SAFETY EVALUATION BY THE OFFICE OF NUCLEAR REACTOR REGULATION

SUPPORTING AMENDMENT NO. 47 TO LICENSE NO. DPR-49

DOCKET NO. 50-331

DUANE ARNOLD ENERGY CENTER

Recirculation System Elevation
 and Isometric

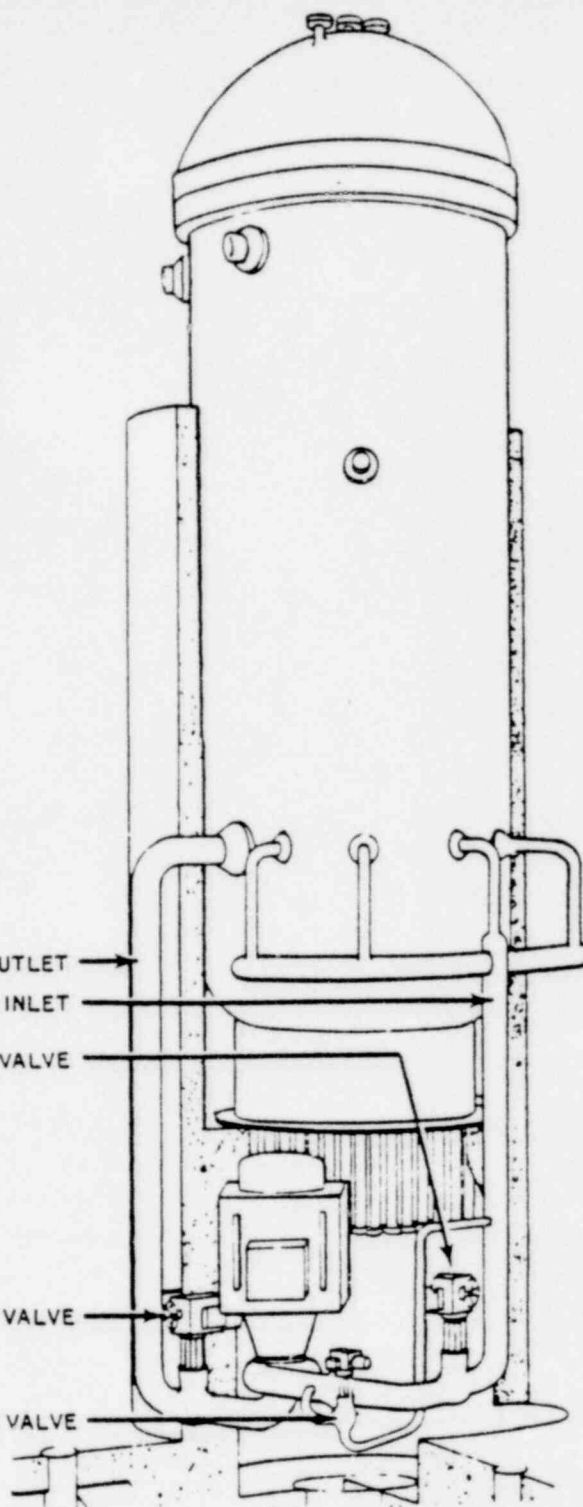
The modification consists of replacing the existing eight cracked recirculation inlet nozzle safe-ends with redesigned safe-ends and thermal sleeve adapters. The safe-ends were fabricated from SB-166 (Alloy 600) material.** They function as transition pieces between the stainless steel reactor recirculation piping and the carbon steel reactor vessel nozzles, and as attachment points for the internal thermal sleeves, that carry the recirculation flow to the jet pump risers (see Figure 1).

WELD BEQUENCE FOR REPLACEMENT SAFE END ASSEMBLY

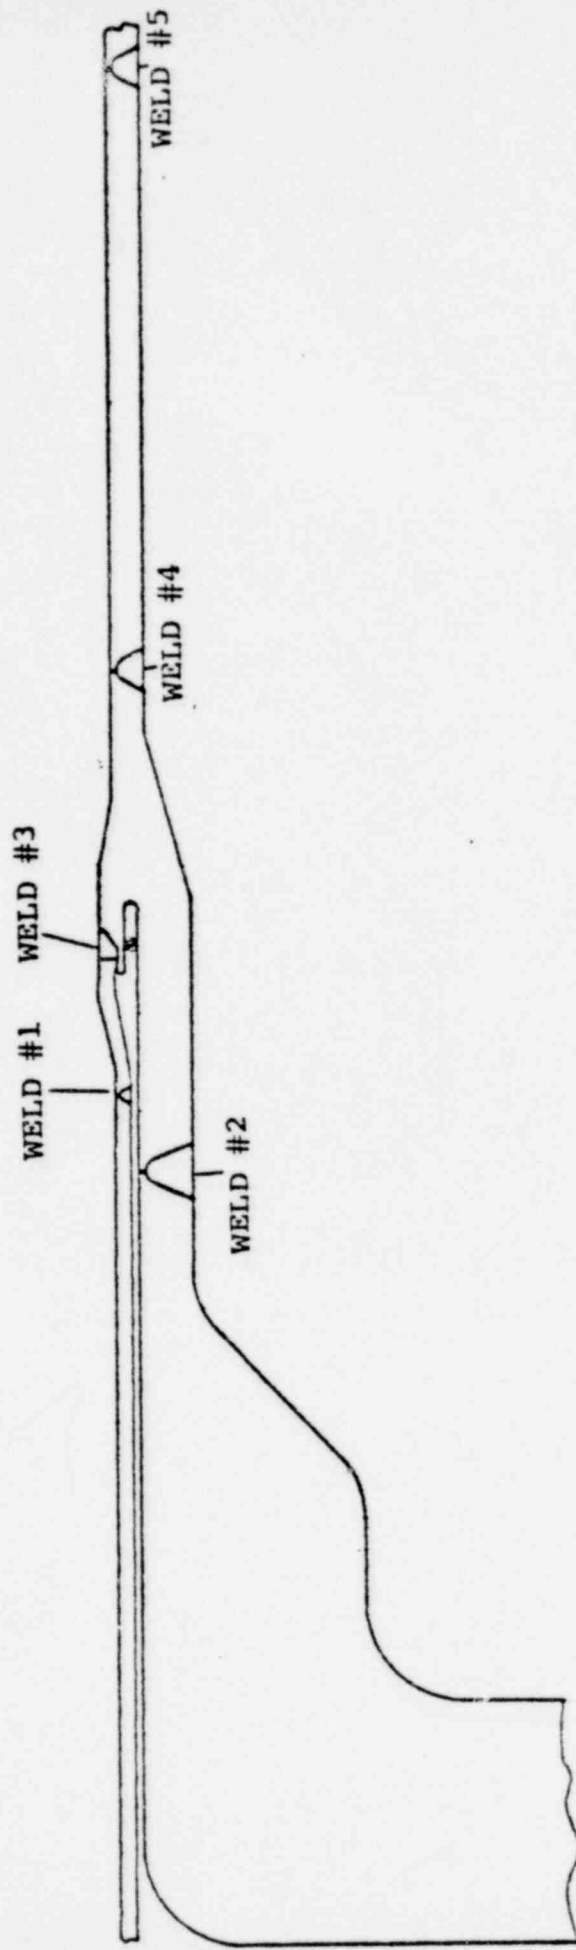
The new safe-end design removes the thermal sleeve attachment weld from the primary pressure boundary and eliminates the sharp crevice in the high residual tensile stress area. In the new design, the thermal sleeve is welded to the safe-end at a point away from the pressure boundary wall (see Weld #3, Figure 2). The new safe-end design improves the in-service inspection access at the nozzle attachment end by maintaining longer straight inside and outside surfaces, thus simplifying ultrasonic angle beam examinations.

The installation of the new assemblies involves five separate welds at each safe-end (see Figure 2). Prior to installation, each weld was mocked up to demonstrate reproducibility of welding and dimensional control of weld shrinkage. Because the root of the production weld between the thermal sleeve and the safe-end could not be examined after welding to confirm that complete fusion was achieved, the mockup weld was sectioned, etched and examined. Although it was observed that the backing ring deformed against the thermal sleeve creating a crevice-like condition, the joint is not located on the primary pressure boundary of the safe-end, therefore if the condition were to induce IGSCC the pressure boundary integrity would be unaffected.
